# CITY OF BLOOMINGTON

# PLAN COMMISSION

March 6, 2017 @ 5:30 p.m.  
COUNCIL CHAMBERS #115  
CITY HALL

**BLOOMINGTON PLAN COMMISSION  
STAFF REPORT – Second Hearing  
Location: 2182 W. Tapp Road**

ADAMS VILLAGE - BLOOMINGTON, IN  
**SCHEMATIC DESIGN**

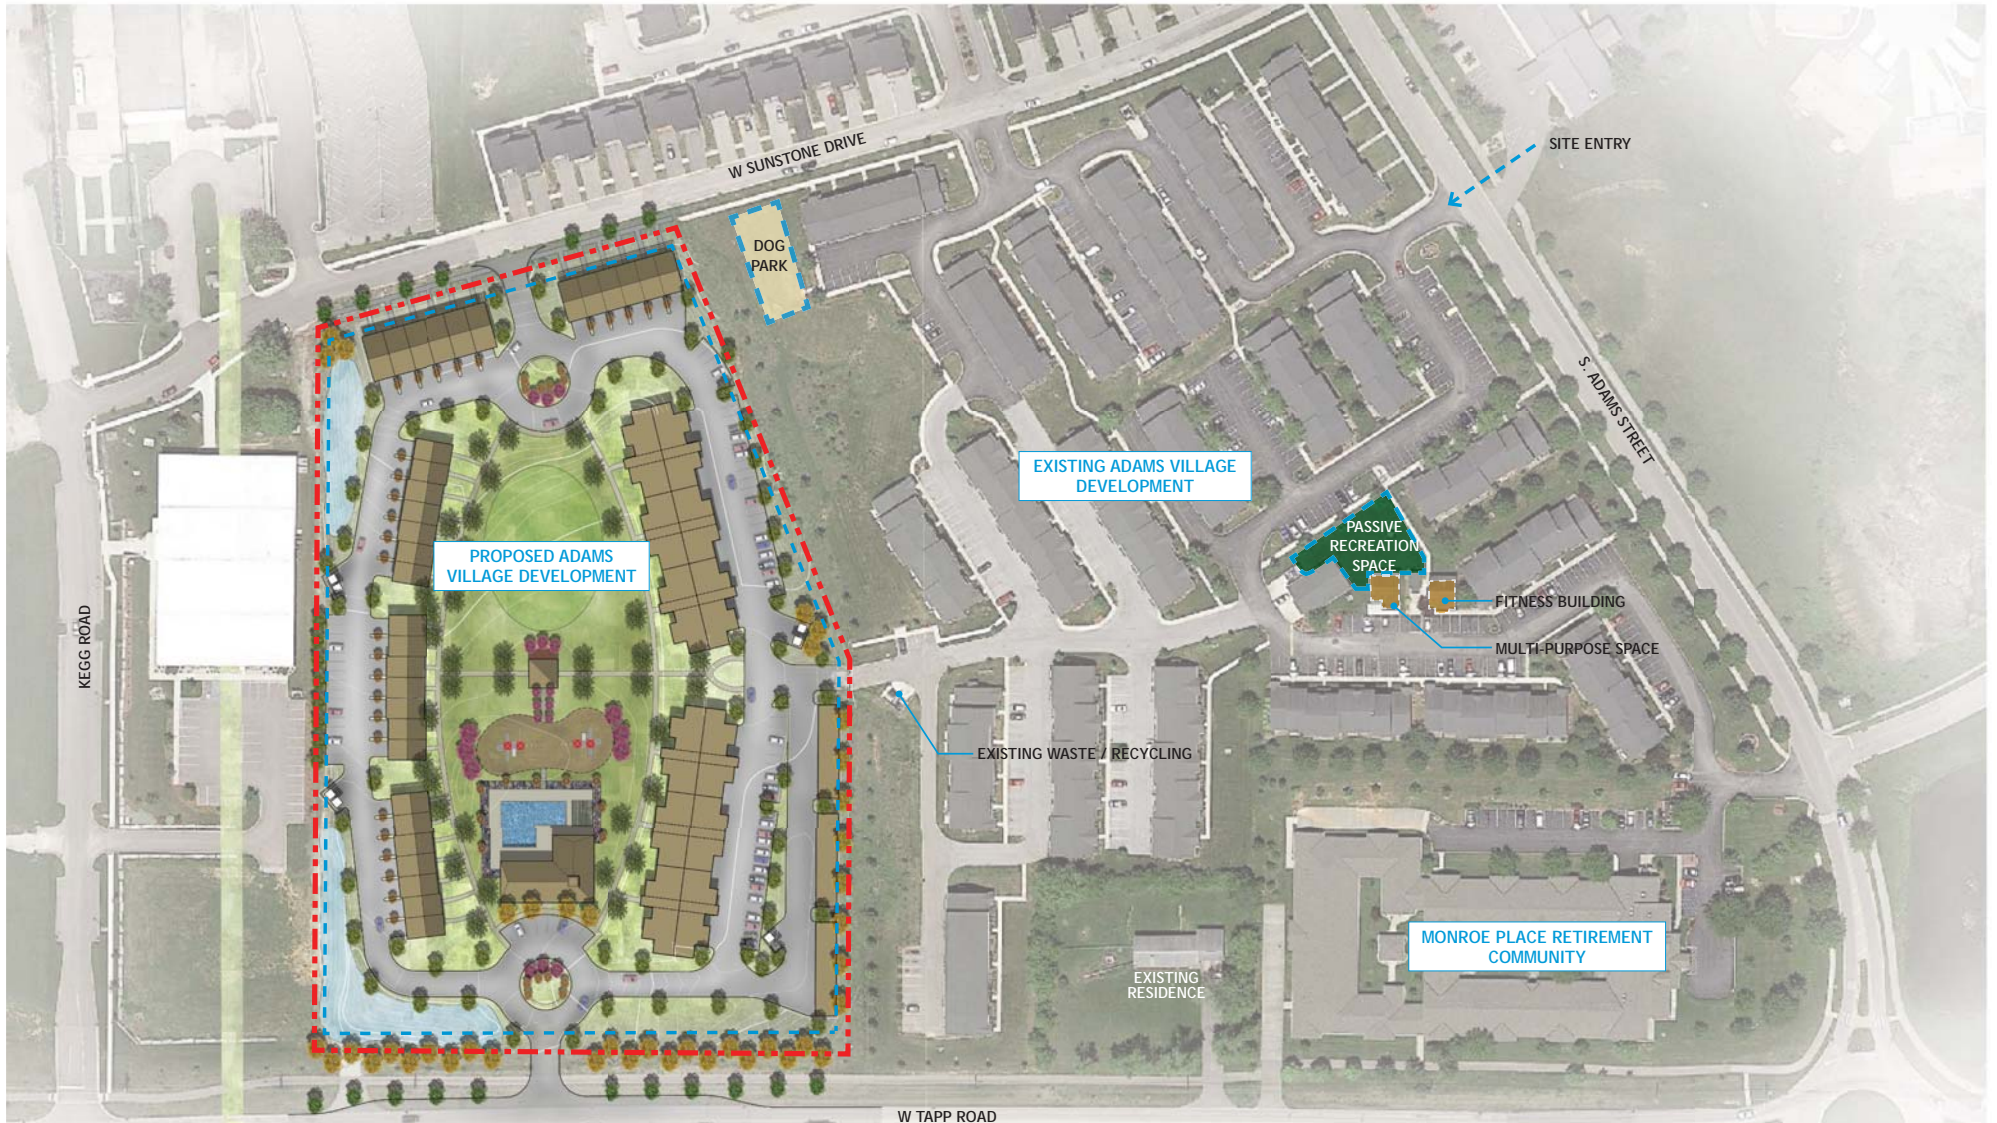
The Petitioner's Statement committed to using native plants; however, there are some listed in the Schematic Design that are not native to south central Indiana. The EC recommends that the Petitioner revise the Landscape Plan to include only native plants, and to increase the number of species beneficial to pollinating animals and insects.

- 1.) The Petitioner should use all native plant species in the Landscape Plan as committed to in the Petitioner's Statement, and increase the amount of species beneficial to pollinators.
- 2.) The Petitioner should commit to salvaging, recycling, and reusing all possible construction materials not needed on site.

# WOOLERY PUD LOT 1 LEFT TURN LANE CONCEPTUAL PLAN

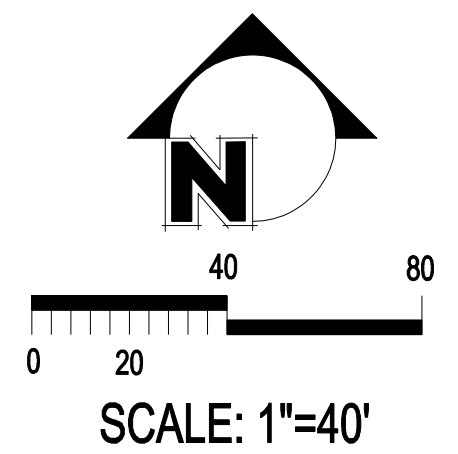
**CHANGES SINCE FIRST HEARING:** At the first hearing the Plan Commission wanted to see more information regarding the proposed height of the buildings relative to the existing buildings at Adams Village, a possible design for a left-turn lane into this development from Tapp Road, and an analysis of the possible karst feature on this site. Staff is also still working with the petitioner on the affordable housing component with this project and will have more information available at the hearing.

- A possible street design for Tapp Road that shows how the road could be modified within the existing right-of-way to provide a dedicated left-turn lane.

1. PUD final plan approval will be reviewed by the Plan Commission.
2. All landscaping for this project shall be native species.
3. If deemed necessary by the Planning and Transportation Department during final plan review, the petitioner shall install a left-turn lane into this project from Tapp Road.
